REQUEST FOR WRITTEN APPROVAL TO USE CONSTRUCTION METHODS NOT
INCLUDED IN THE RULES AND REGULATIONS PRESCRIBING GENERAL STANDARDS
FOR THE CONSTRUCTION AND MAINTENANCE OF WELLS IN OREGON

(1) Location of Well: N.E. 1/4 S.W. 1/4 of Section 18,
Township 5 S, Range 1 E, Clackamas County.

(6) A diagram showing the pertinent features of the proposed well design and construction (attach additional sheet if necessary):

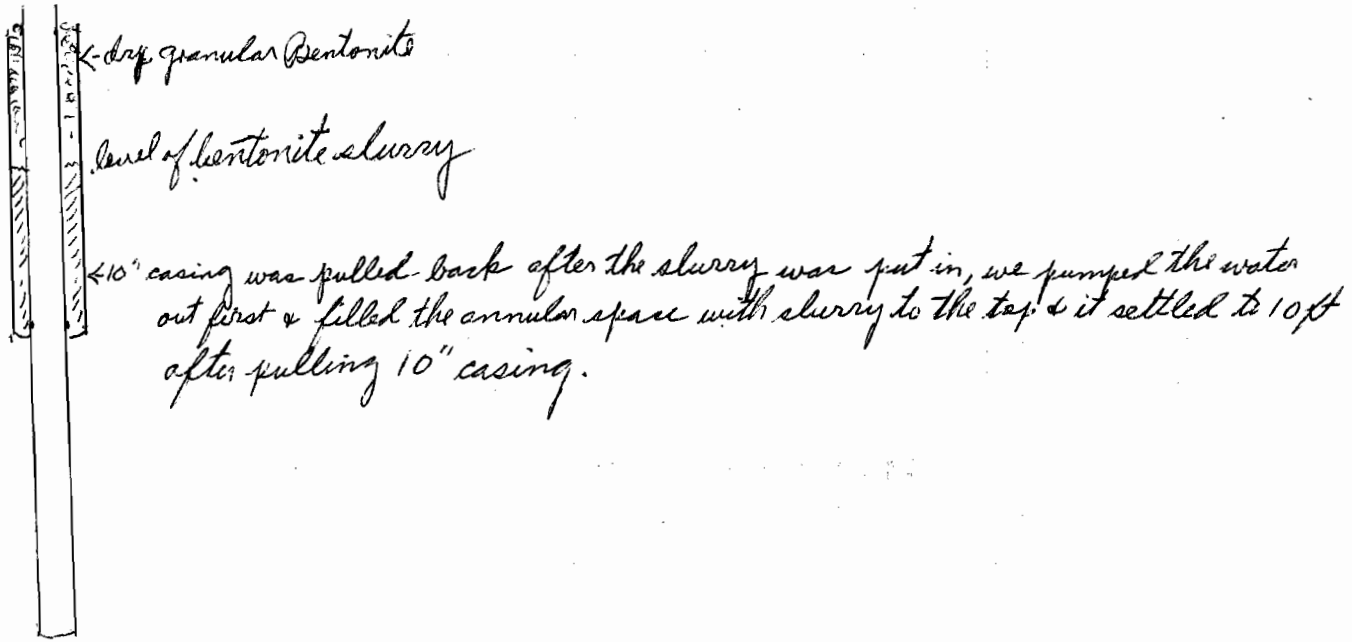
(4) The unusual conditions existing at the well site: We encountered &
caving formation around 15 ft. & installed a 10" casing until
we were thru drilling & then pumped the water out the rear in -

the annular space & being as the walls were wet we
didn't want to pour the dry granular down & needed
to put in the bentonite slurry. That is what I called
you about, but I'm sorry that I forgot about it &
I didn't call in until after we had put in the slurry.
you said to make a note & send it along with the
log & that is what this is for. Thank you - over.

Date: 5-30-89

Approved by: [Signature]
